BEFORE THE BOARD OF ZONING ADJUSTMENT
OF THE DISTRICT OF COLUMBIA

FORM 125 - APPEAL

Allowed for the granting of Building permit B1408491

for the construction of 8 unit apartment building with only 3 parking spaces in R-5-B zone that requires 4 parking spaces. Approved building also exceeds the allowable FAR and Lot Coverage

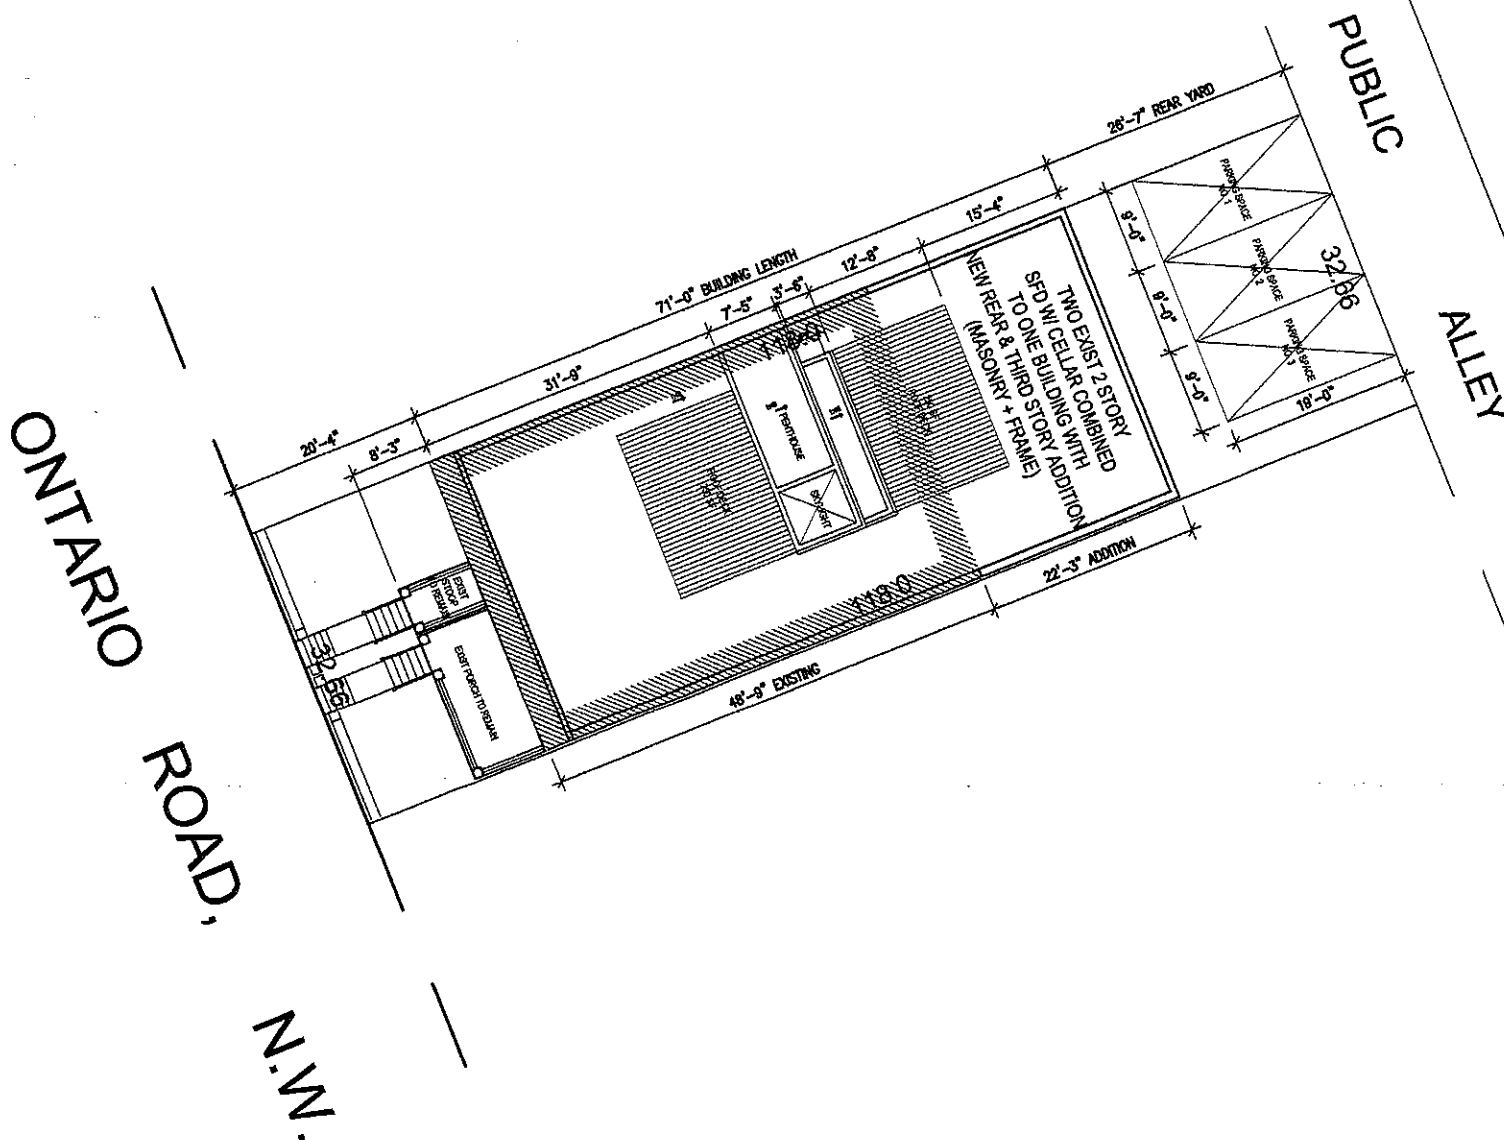
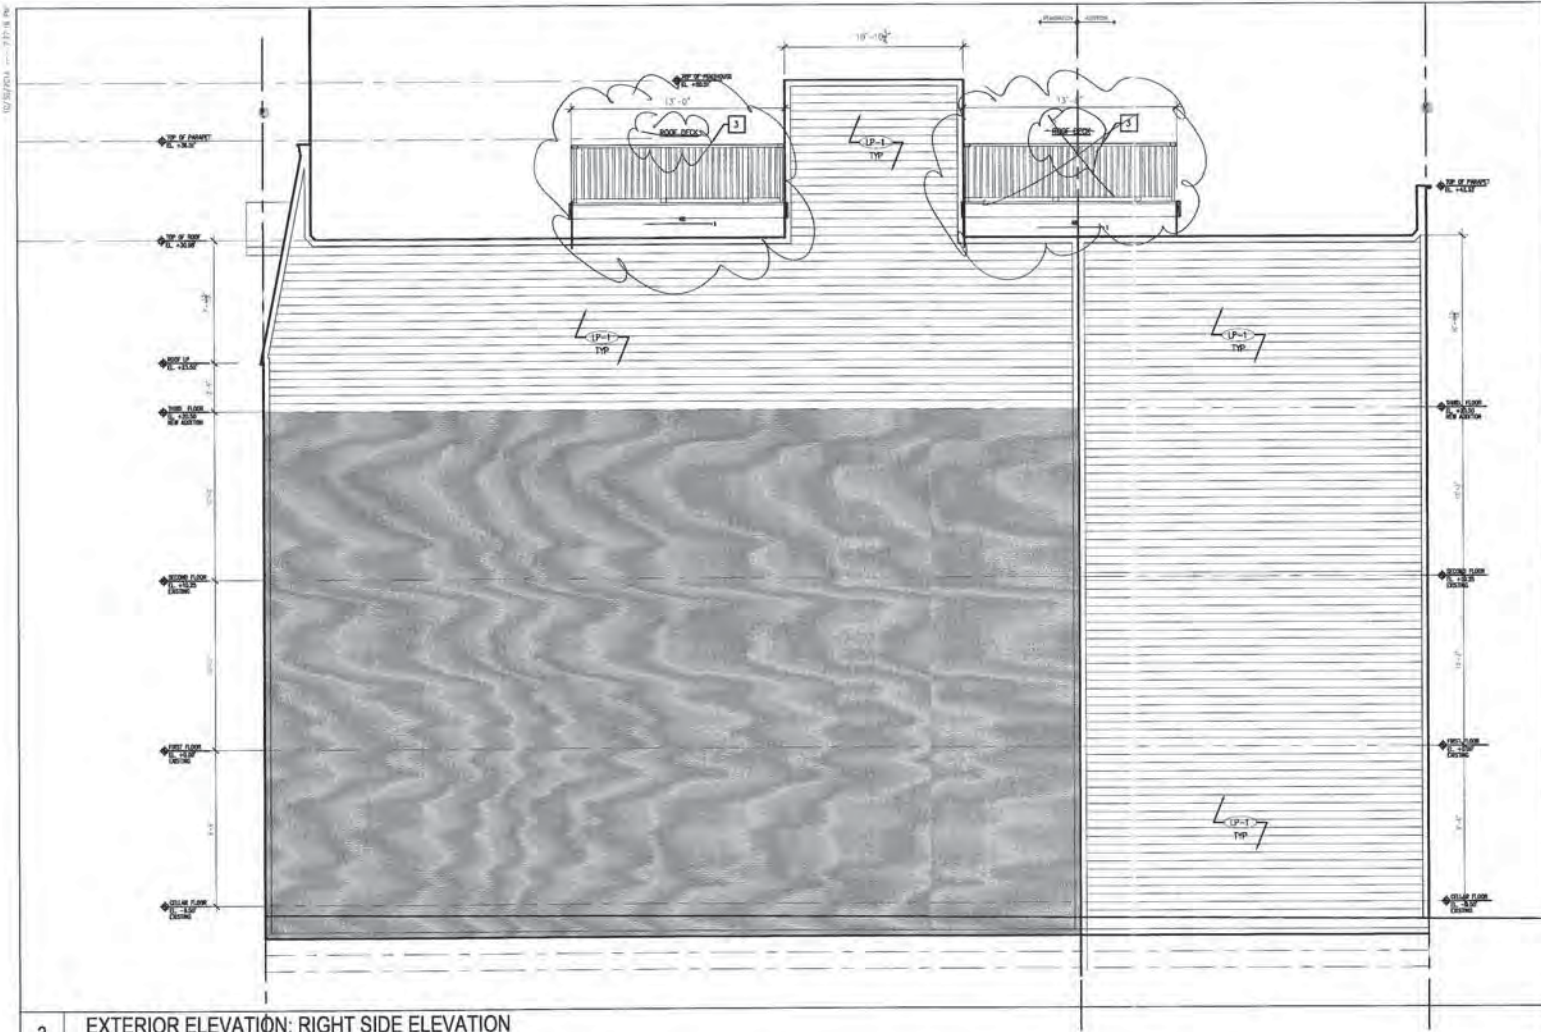
- a) **There should be no roof deck.** The DC Surveyor's plat approved by DC Zoning shows roof decks which were omitted from the plans at the request of the DC Structural review (see Exhibit 6 sheet A103). These should have been removed from the DC Surveyor's plat, to clearly reflect that a common roof deck is not included in the approved permit. This would require 2 means of egress (not in the plans) as required by Section 1021 of The District of Columbia Building Code of 2013 for an occupied roof located at the fourth story and could be very noisy for an otherwise relatively quiet street.

- b) **Steps and stoops.** Additionally the DC Surveyor's plat approved by DC Zoning contains the following discrepancies: 1. Front and rear exterior steps leading to the cellar units are not shown. 2. The plat shows an existing stoop to remain at a different location from the building main entrance stoop on the permitted architectural plans (see Exhibit 6 sheet A101).

- c) **Building length.** The building length on the DC Surveyor's plat is noted as being 71'-0" long but in the plans it is noted as being 70'-10".
 - d) **The developer should be required to correct these inconsistencies.** The permit should be withdrawn due to these inconsistencies.

2 EXTERIOR ELEVATION: REAR FACADE
SCALE: 1/4" = 1'-0"

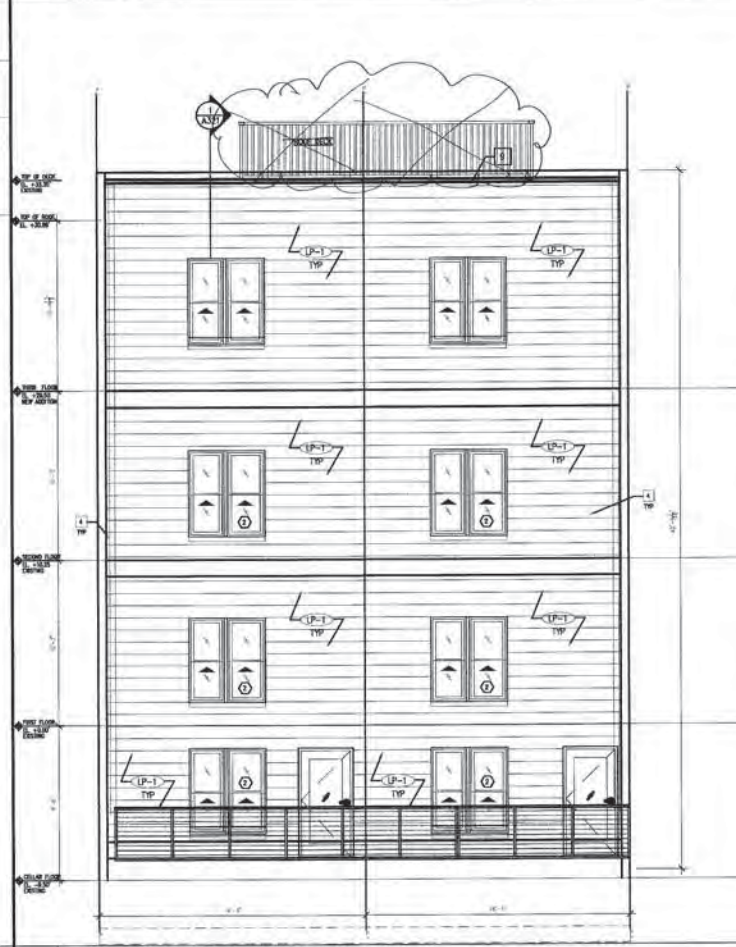
- b) **Lot coverage may be even greater.** The Permit plans list two elevations titled as "rear" (2/A201, 1/A201 see Exhibit 6) that show a 4-story building. One of these elevations is perhaps actually the front elevation (2/A201) and it shows balconies. If the balconies are added to the front, as shown in the elevations but not on the plat, the building lot coverage will be exceeded even further. These elevations are not coordinated with the building floor plans and building sections. The Zoning reviewer noted these issues in the Permit Status website, but as far as we can tell this inconsistency has not been corrected.

- b) **FAR may be even greater.** The Permit plans list two elevations titled as "rear" (2/A201, 1/A201 see [Exhibit 6](#)) that show a 4-story building. One of these elevations is perhaps actually the front elevation (2/A201) and it shows balconies. The FAR is calculated as a 3-story building with a cellar. If the building is indeed a 4-story building it would exceed the FAR by a very large amount. These elevations are not coordinated with the building floor plans and building sections. The Zoning reviewer noted these issues in the Permit Status website, but as far as we can tell this inconsistency has not been corrected.
